**Remedial Investigation and
Feasibility Study Work Plan
Revision 1**

Nevada Environmental Response
Trust Site; Henderson, Nevada

Prepared by:
**ENVIRON International Corporation
Emeryville, California**

Date:
January 10, 2014

Figure
7-1

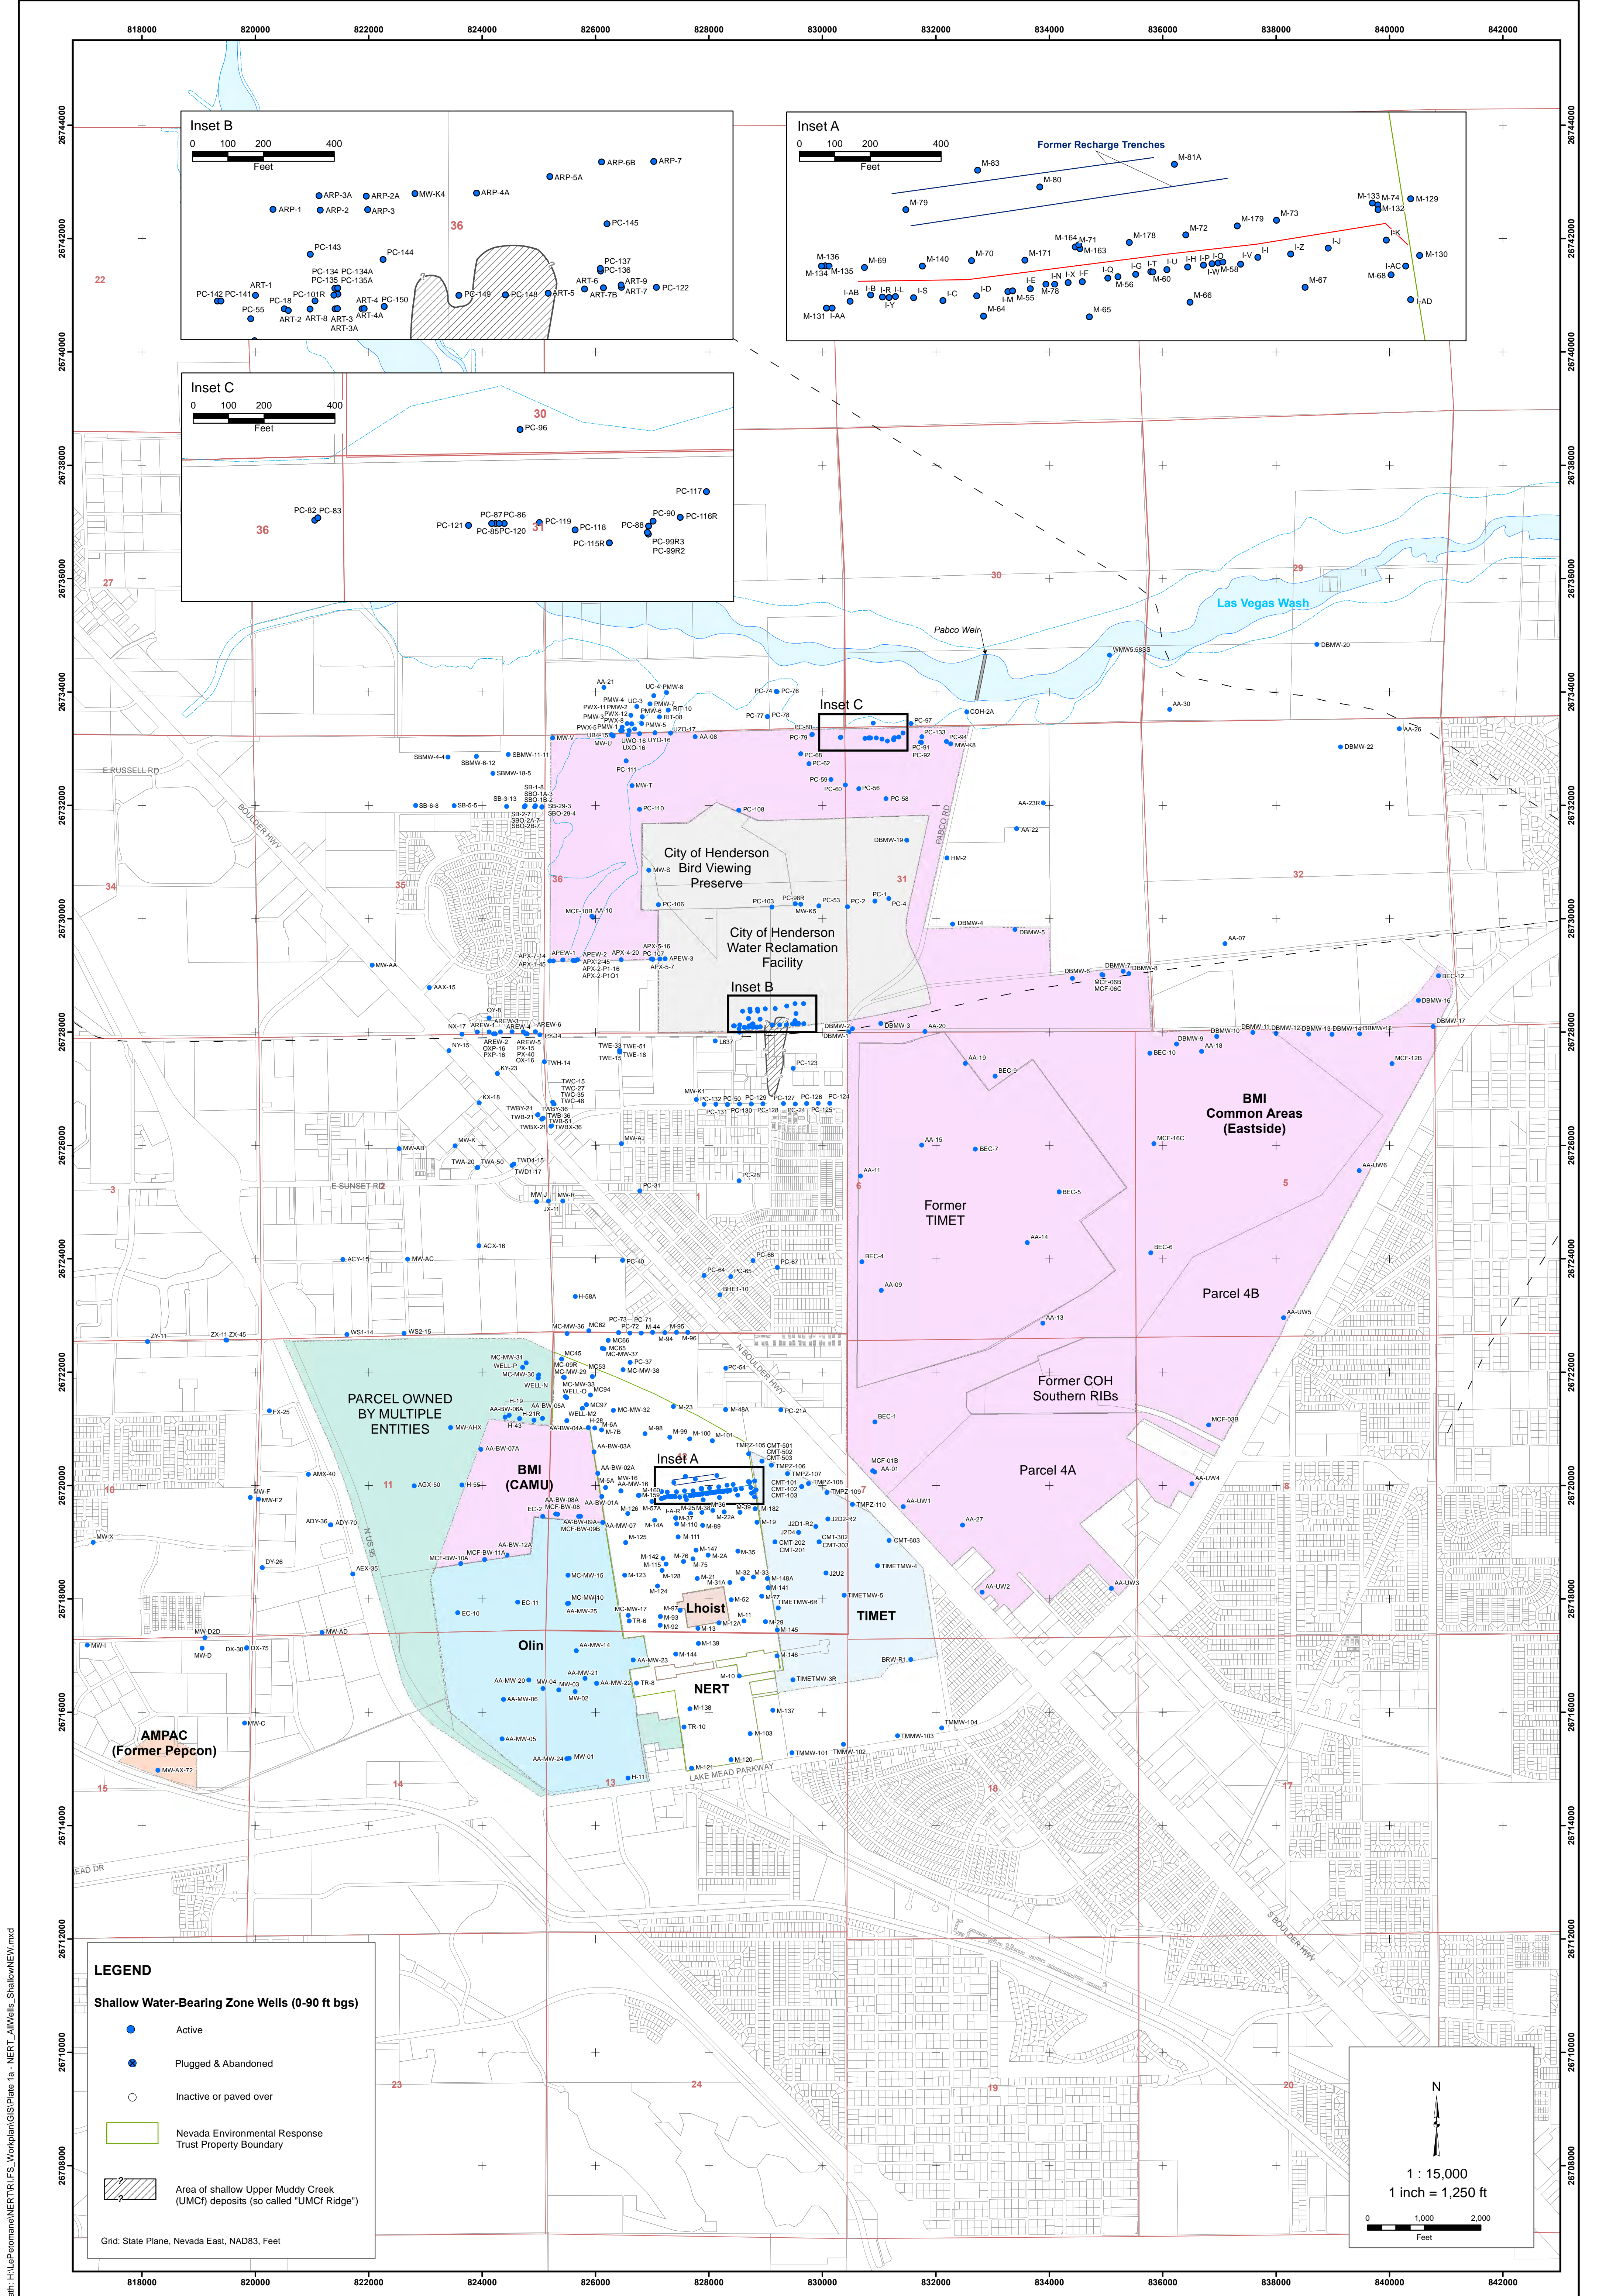
80. Figure 7-1 Remedial Investigation and Feasibility Study Schedule, this figure presents a timeline for a baseline HRA work plan. Please clarify whether the Trust plans on submitting a new HRA work plan or revise the existing one (Northgate 2010).	See response to Comment #5.

Plate
4

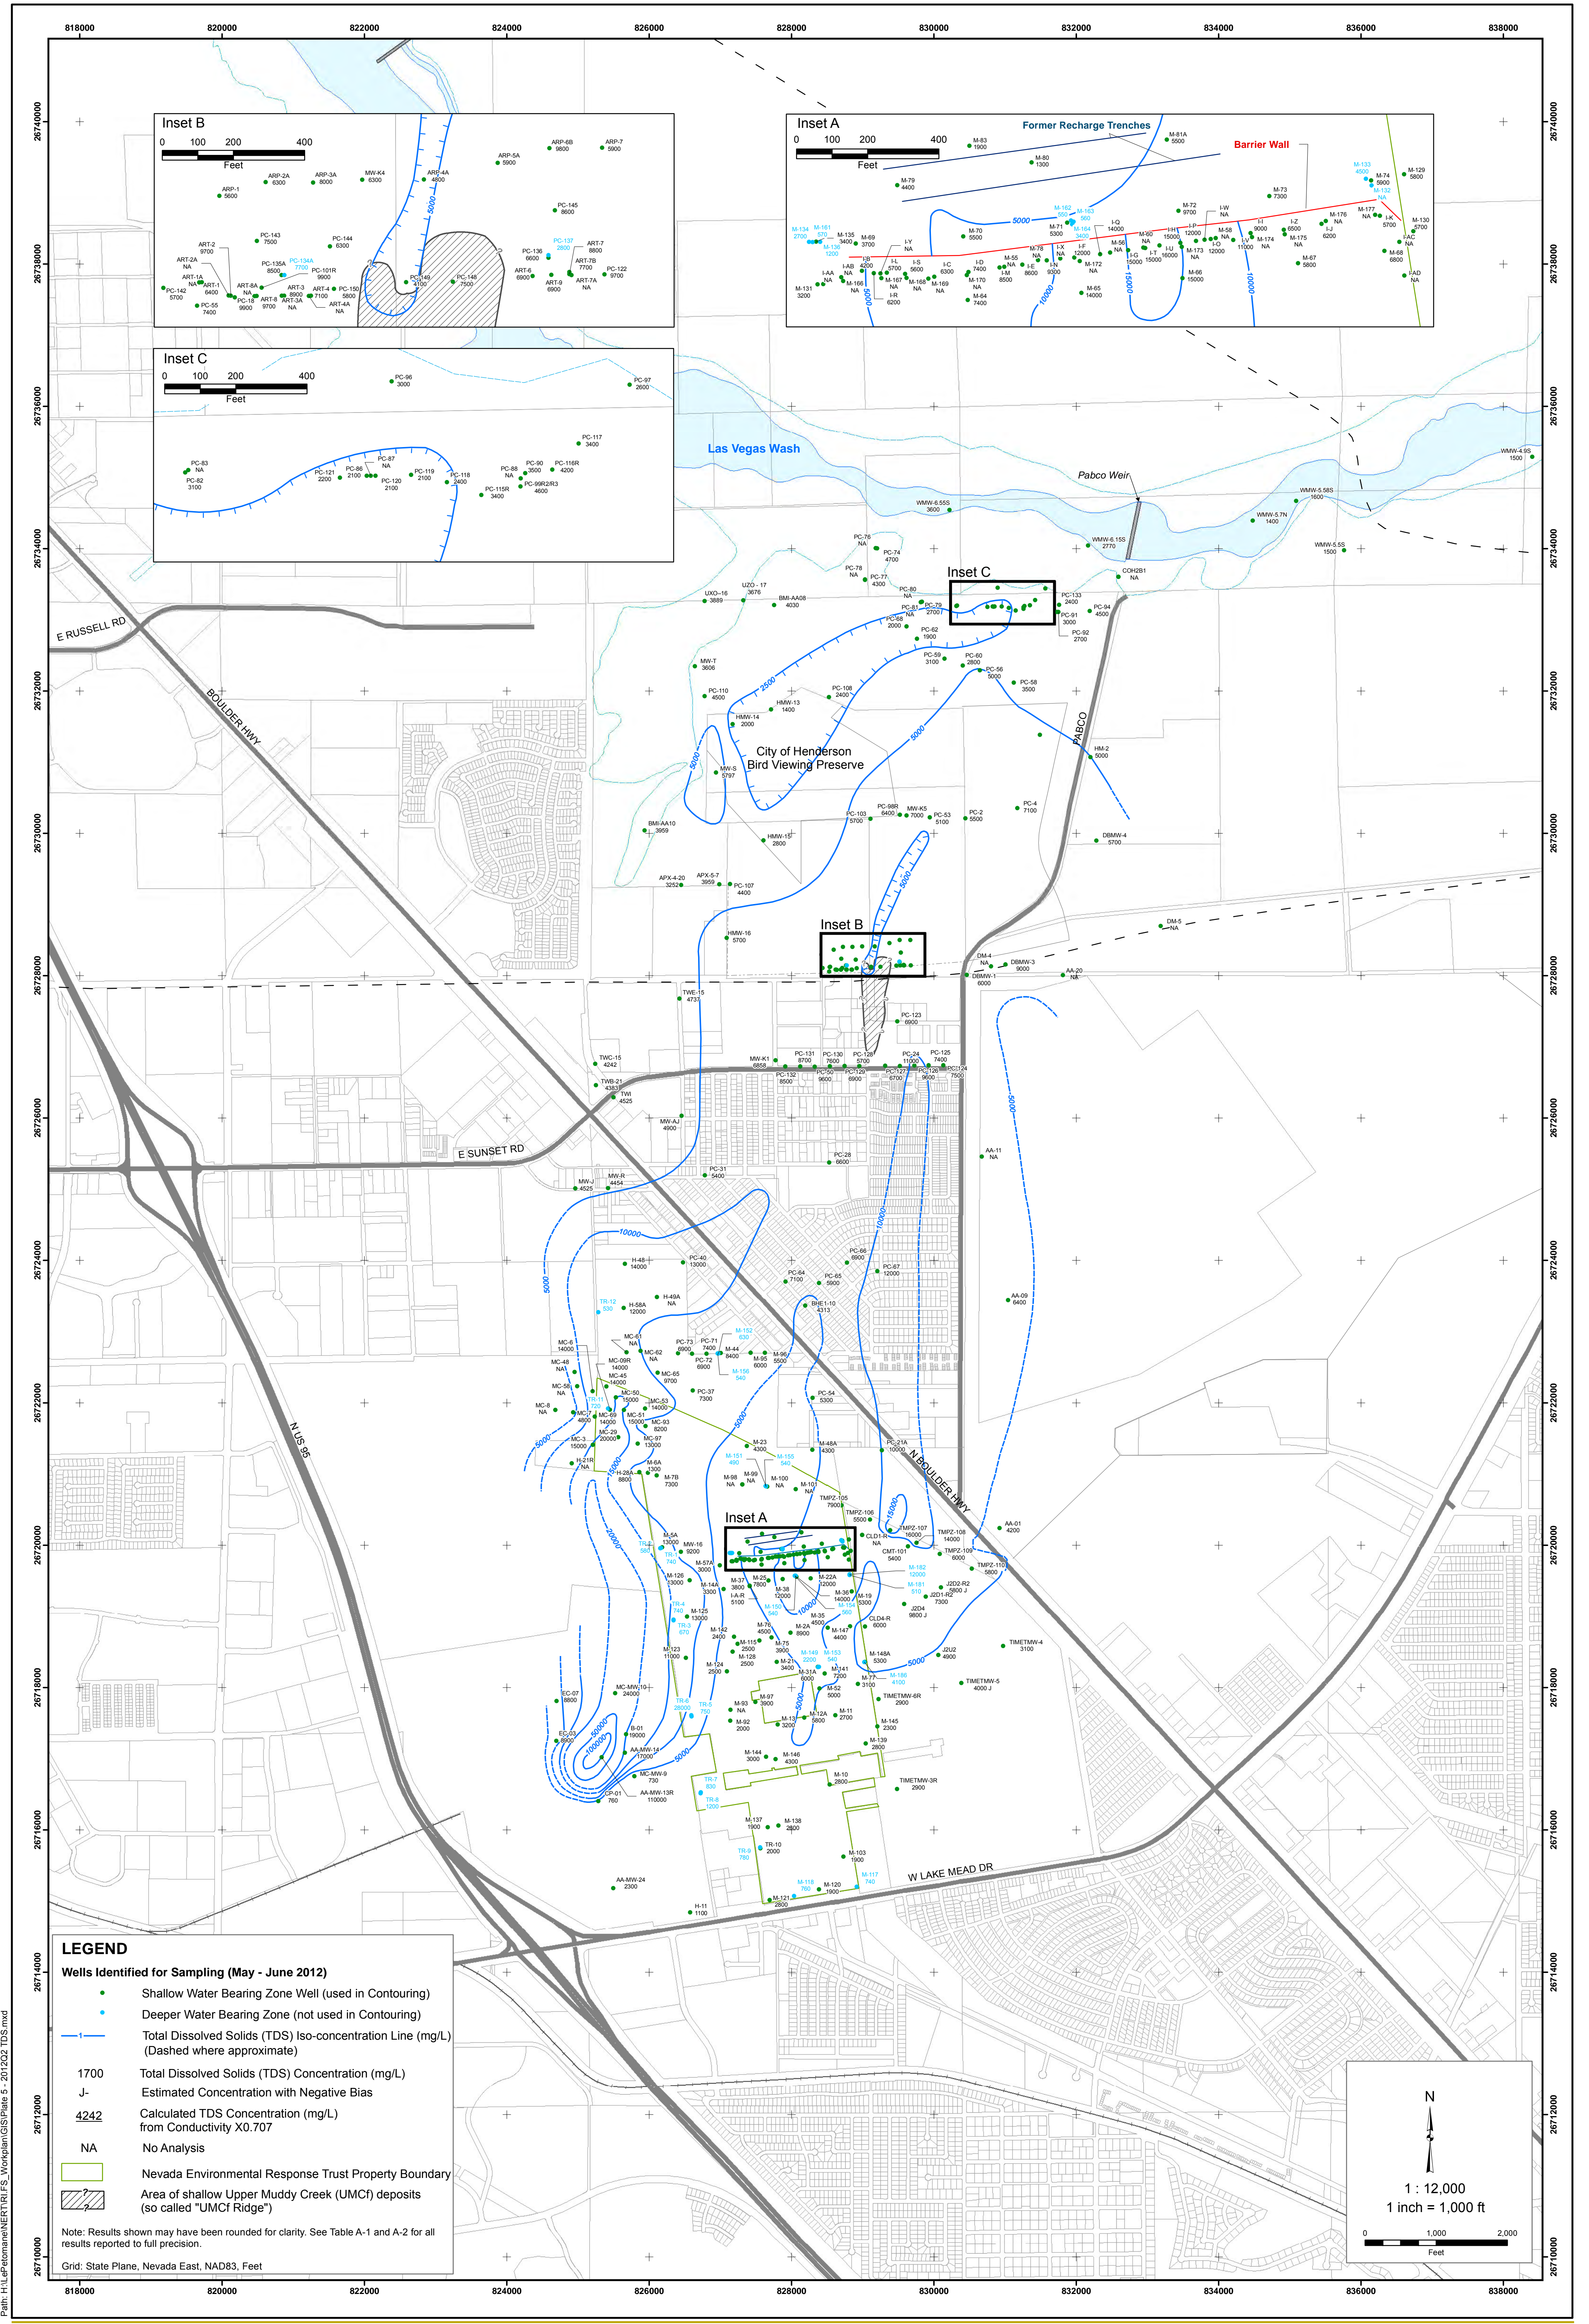
82. Plate 4 shows WMW5.7N as containing "< 3 mg/L", which is correct; but actual values are probably much lower. For example, WMW5.8SI is something over 200 µg/L. These need to be depicted in more detail to help understand the conditions near the Pabco Weir. TDS is similarly too grossly scaled, showing nothing < 5000 mg/L.	The maps were developed using data available at the time. As part of preparing the revised RI/FS Work Plan, additional data will be sought from the Southern Nevada Water Authority (SNWA) and others as appropriate in order to refine the interpretations in this area.

83. Plate 4 Groundwater Total Chromium Map, Shallow Water-Bearing Zone. The Call-out maps shows the perchlorate concentrations instead of the total chromium concentrations.	This will be corrected in the revised RI/FS Work Plan.
